# REHABILITATION STRUCTURE SURVEY REPORT

Design Project ID 1021-03-10	Construction Project ID	Highway (Project Name) STH 93			
Final Plan Due Date February 1, 2020	Preliminary Plan Due Date May 1, 2019	<input checked="" type="checkbox"/> Town <input type="checkbox"/> Village <input type="checkbox"/> City Washington			
PS&E Date May 1, 2020	Letting Date July 9, 2024	County Eau Claire			
Structure Number B-18-0034		Section 3	Town 26N	Range 9W	
Station 669+79	Latitude: 44.765804 Longitude: -91.459132	<input type="checkbox"/> YES <input type="checkbox"/> NO    Structure Located on National Highway System			
For Survey and CADD Files Horizontal Coordinate System: Eau Claire County Vertical Datum: NAVD88		<b>Traffic Forecast Data</b>			
		Design Year	Average Daily Traffic (ADT)	Roadway Design Speed	Functional Class
Feature On STH 93 SB		Feature On 2042	25400	45 MPH	Principal Arterial
Feature Under IH 94		Feature Under 2042	38800	70 MPH	Principal Arterial

**Subject: DNR Initial Project Review**  
Project I.D. 1021-03-10/80  
STH 93 Bridges B-18-0034, B-18-0119  
Eau Claire County  
T26N, R9W, Section 3

North Abutment

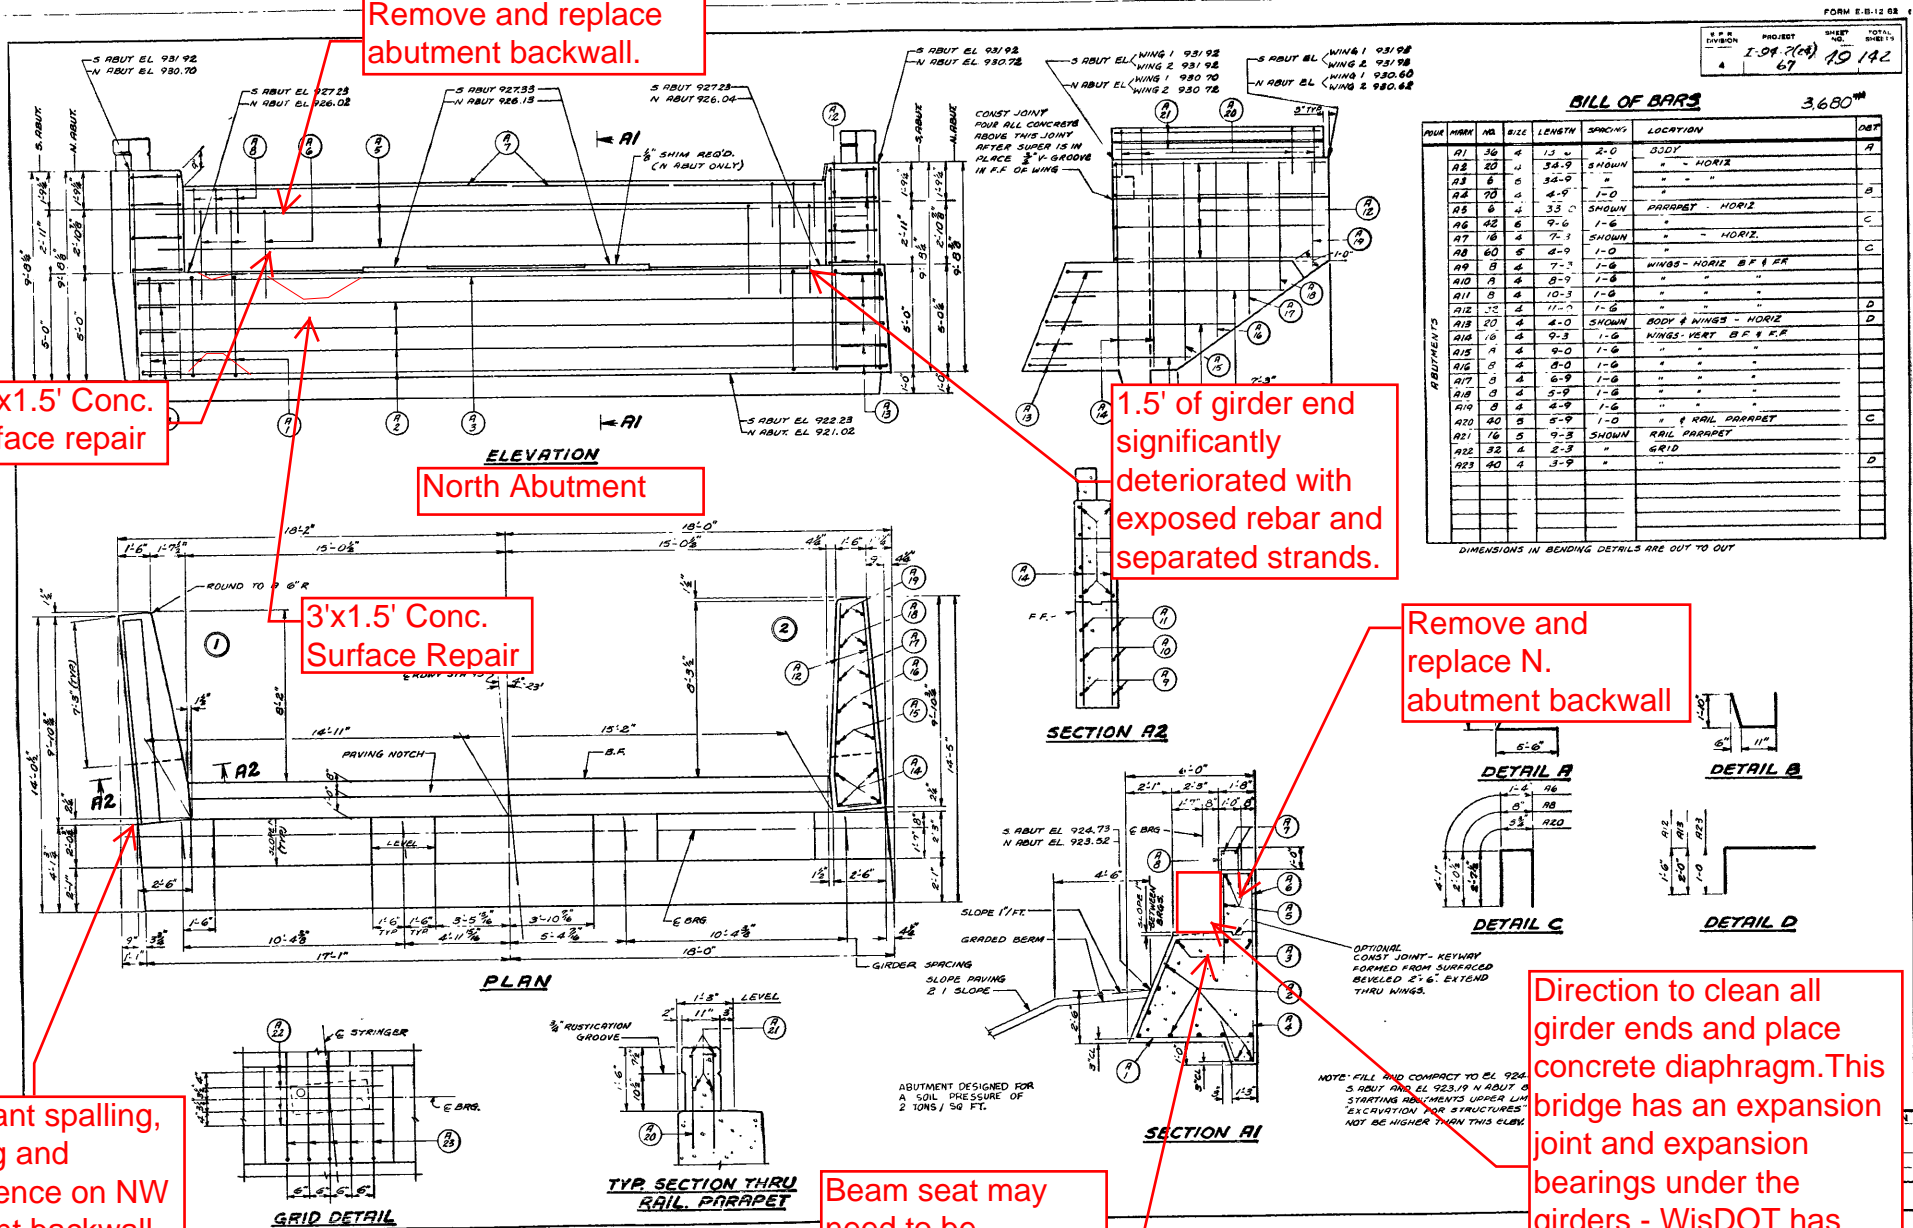
Remove and replace abutment backwall.

2.5'x1.5' Conc. Surface repair

3'x1.5' Conc. Surface Repair

Significant spalling, cracking and efflorescence on NW abutment backwall and beam seat.

Beam seat may need to be removed to a certain elevation.

ELEVATION  
LOOKING NORTH

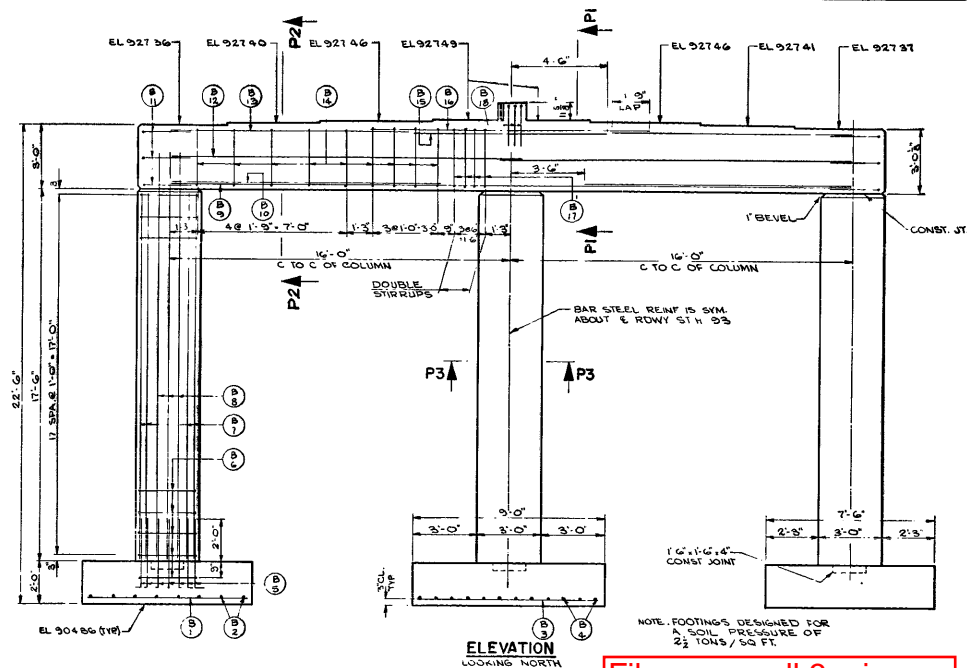
1.5' of girder end significantly deteriorated with exposed rebar and separated strands.

Remove and replace N. abutment backwall

Direction to clean all girder ends and place concrete diaphragm. This bridge has an expansion joint and expansion bearings under the girders - WisDOT has directed for a bearing conversion to occur.

REVISION	STATE HIGHWAY COMMISSION OF WISCONSIN
PROJECT	PIER 1
DESIGN BY	A.A.S.H.O. 101 (LOADING H20 S16) 1965
DATE	11-7-63
BY	V.G.M. FORAN J.C.K. LEO
STRUCTURE	B-18-34
SHEET	9 OF 12

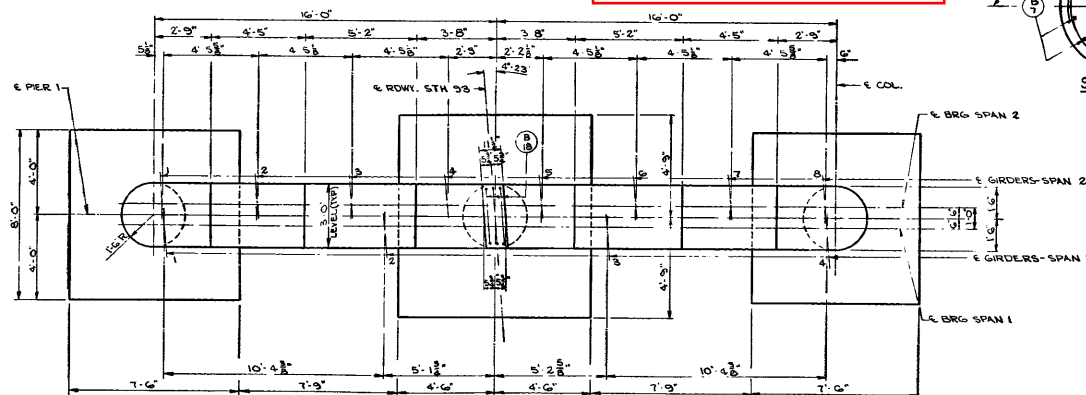
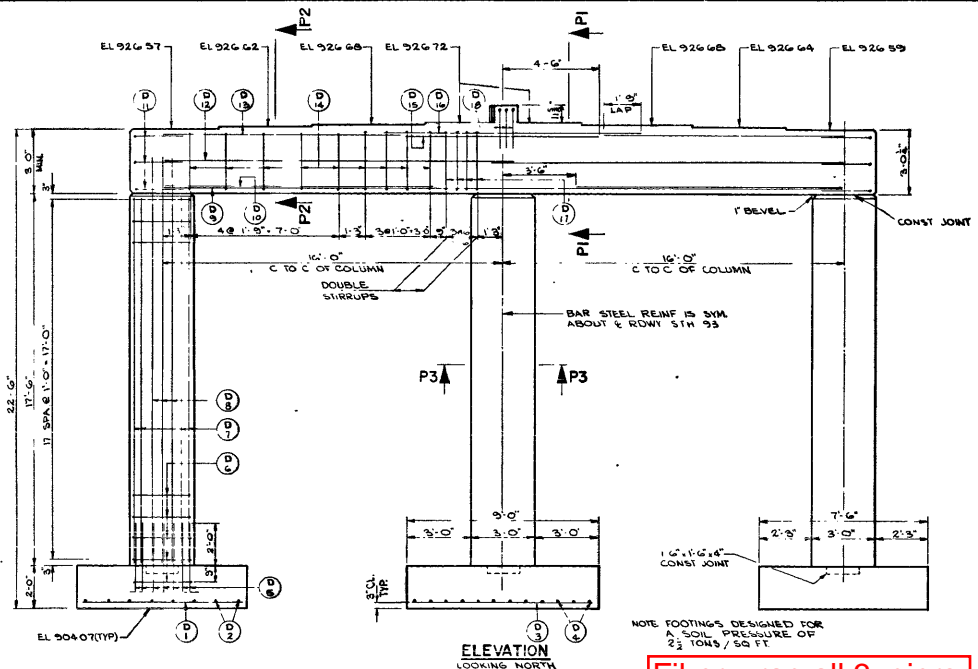
Fiber wrap all 3 piers

STATE HIGHWAY COMMISSION OF WISCONSIN  
PROJECT: I-94 (201) 52 142  
SHEET: 67  
STRUCTURE: B 18-34  
SHEET: 11 of 12  
X 27945

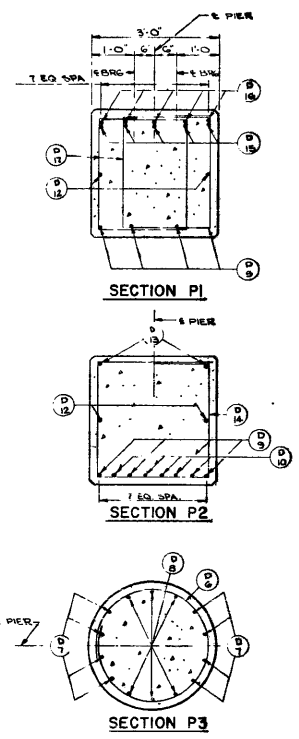
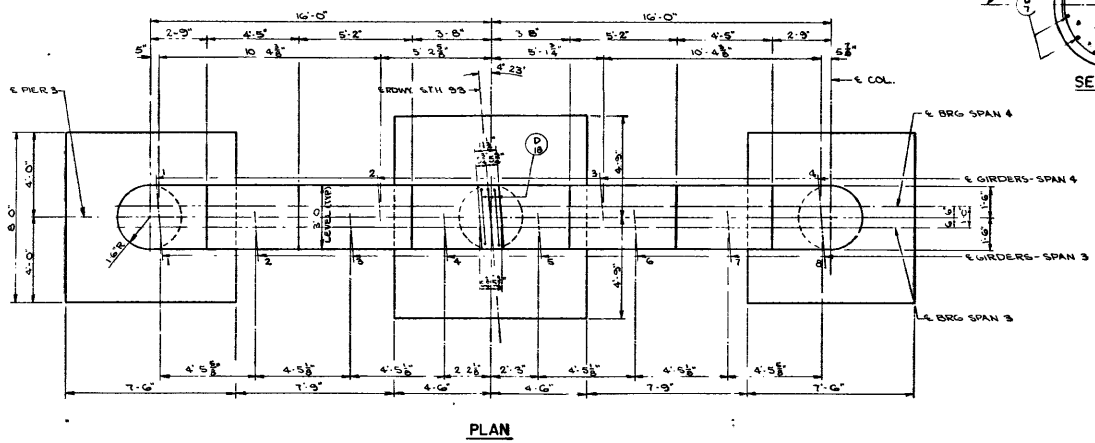
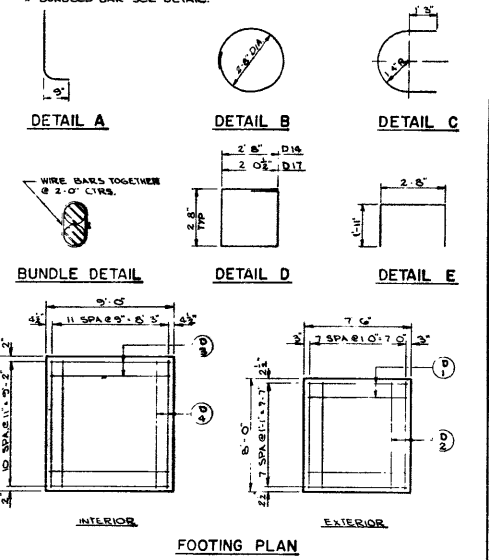
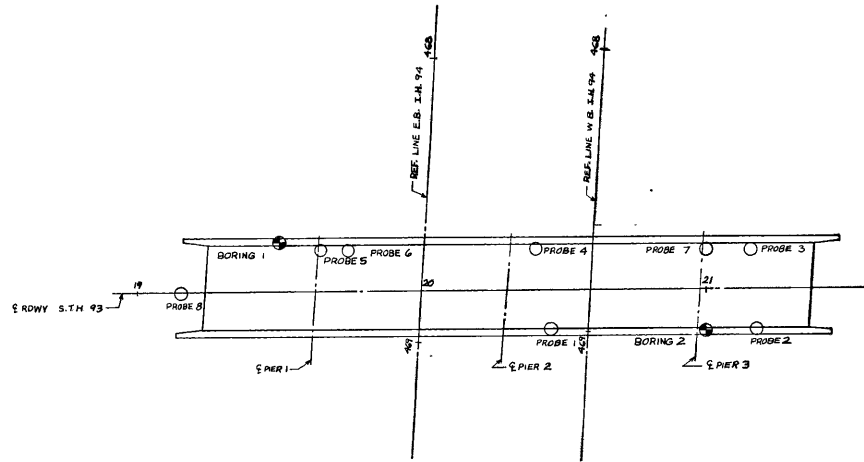
Fiber wrap all 3 piers
